MIL-M-28787/163A(SH)
AMENDMENT 1
23 March 1992

MODULES, STANDARD ELECTRONIC

DRIVER, INTERFACE, DIGITAL, KEY CODE EKC

FIGURE 6. Life test circuit waveforms

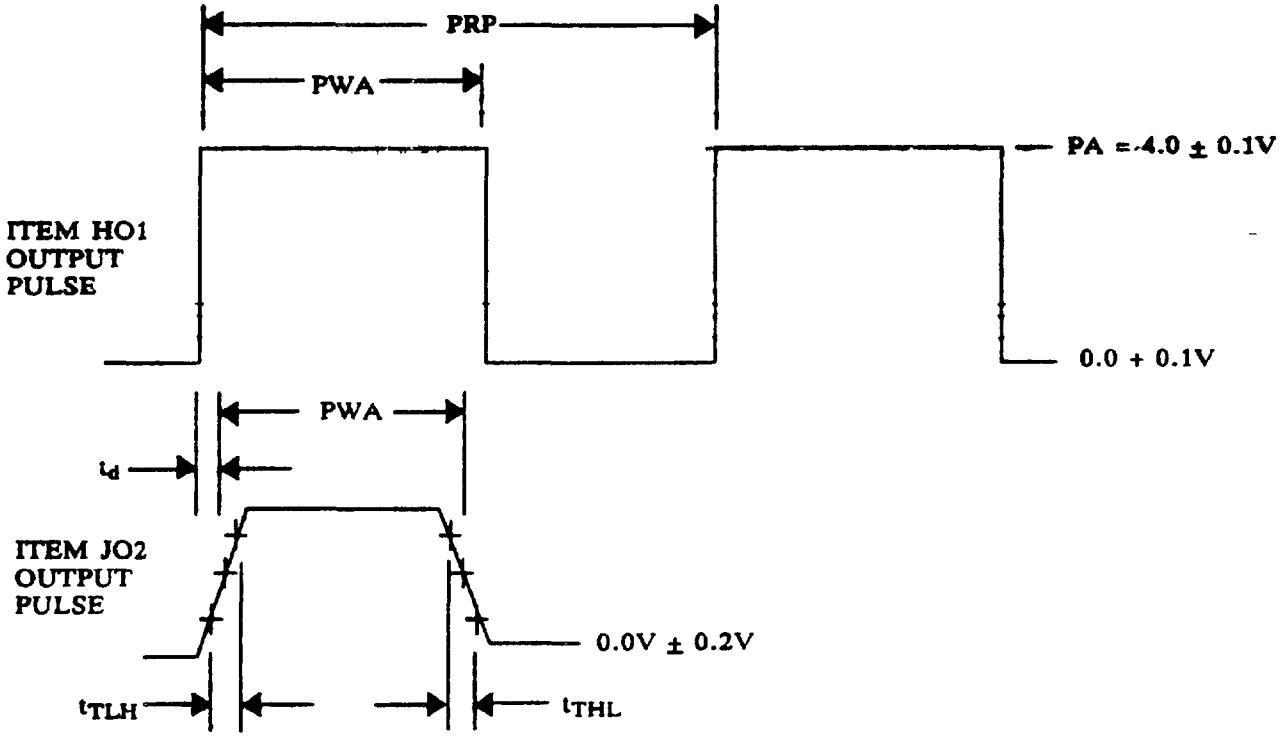
FIGURE 6: Delete and substitute new figure 6 as printed on page 3 of this amendment.

NOTES
1. Item H01 pulse parameters:
   PWA = 2.5 ± 0.5s.
   PRP = 5 ± 1s.
2. Item J02 pulse parameters:

$PWA = 15^{+0.0}_{-0.5}$ ms.

$t_{TLH} = t_{THL} = 50 \pm 5ns$
   $t_d = 0ns \pm 50ns$
